PETITION FOR REVIVAL OF AN APPLICATION FOR PATENT
ABANDONED UNINTENTIONALLY UNDER 37 C.F.R. § 1.137(b)

Title: CALENDER ROLLERS AND METHOD FOR PRODUCING LAMINATED SHEET

**STATEMENT FOR PETITION TO REVIVE UNDER 37 C.F.R. § 1.137(b) AND
PAYMENT OF FEE UNDER 37 C.F.R. § 1.17(m)**

AMENDMENT UNDER 37 C.F.R. § 1.116

FIG. 1A

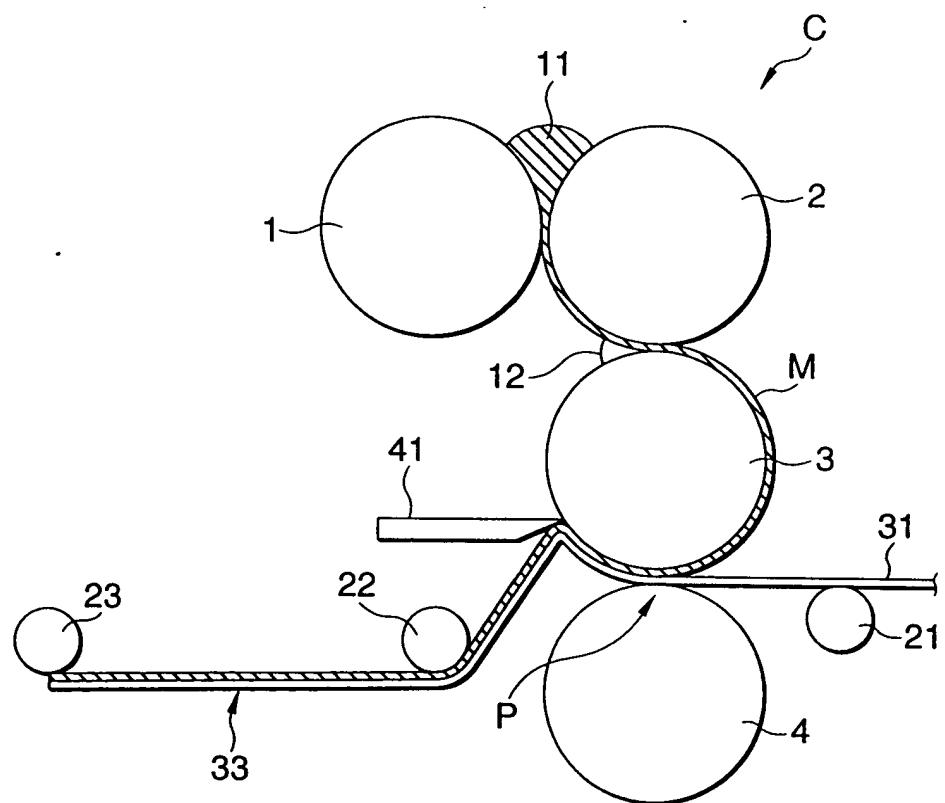
Submitted herewith please find 3 sheets of proposed drawing corrections (Figs. 1A, 1B and 1C) indicated in red ink with the changes described below. The Examiner is respectfully requested to acknowledge receipt of the drawing corrections and to approve the changes.

Fig. 1A is a view illustrating calendar rollers provided with a doctor knife disposed behind a nip portion of a center roller (holding roller) for holding a plastic material sheet. Fig. 1B illustrates a means for heating a release member with a band heater, indicated by reference number 42, attached to a doctor knife, indicated by reference number 41. Fig. 1C illustrates a means for vibrating a release member with an air cylinder, indicated by reference number 43, attached to a doctor knife, indicated by reference number 41.

FIG. 1C

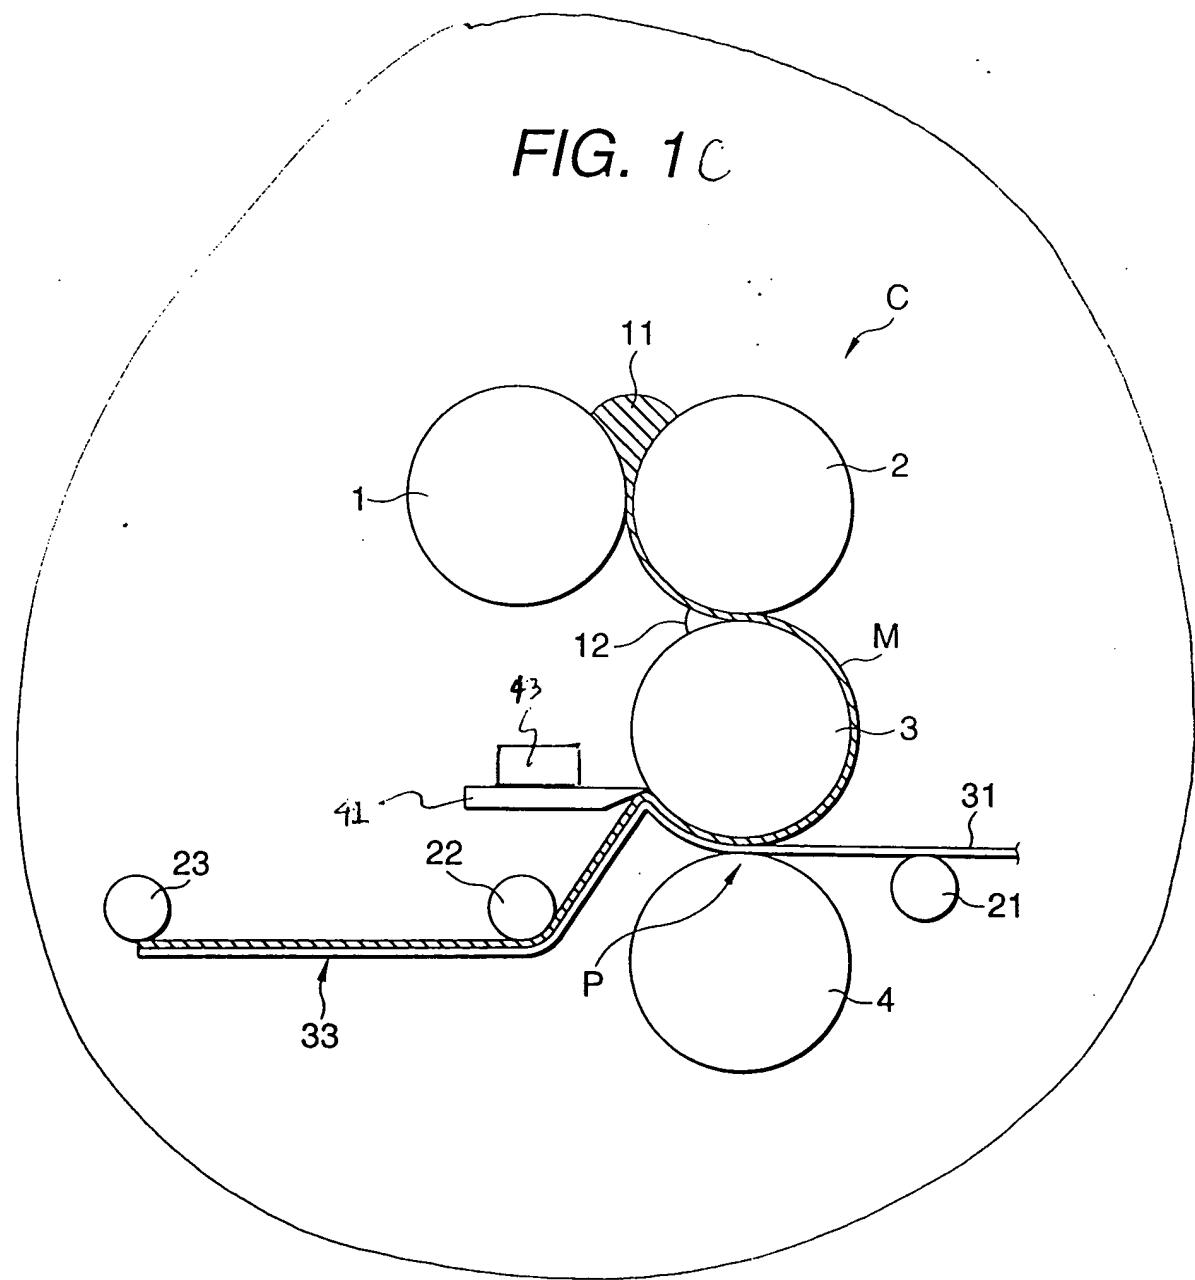
The drawings are objected to under 37 CFR 1.83(a). The drawings must show every feature of the invention specified in the claims. Therefore, means for heating (claim 2), means for vibrating (claim 3), a band heater (claim 11), and an air cylinder (claim 12) must be shown or the feature(s) canceled from the claim(s). No new matter should be entered.

The Examiner has objected to the drawings under 37 CFR 1.83(a) because the drawings allegedly do not show every feature of the invention specified in the claims. The Examiner states that means for heating (Claim 2), means for vibrating (Claim 3), a band heater (Claim 11), and an air cylinder (Claim 12) must be shown or the feature(s) canceled from the claim(s).

Applicants submit a Request for Approval of Proposed Drawing Corrections concurrently herewith and provide corrected drawings showing the means for heating (a band heater) in Fig. 1B and the means for vibrating (an air cylinder) in Fig. 1C. The conventional features of a band heater and an air cylinder are illustrated in the drawings in the form of labeled rectangular boxes as their detailed illustrations are not essential for a proper understanding of the invention, in accordance with 37 C.F.R. § 1.83. Accordingly, Applicants respectfully request withdrawal of the objections to the drawings.
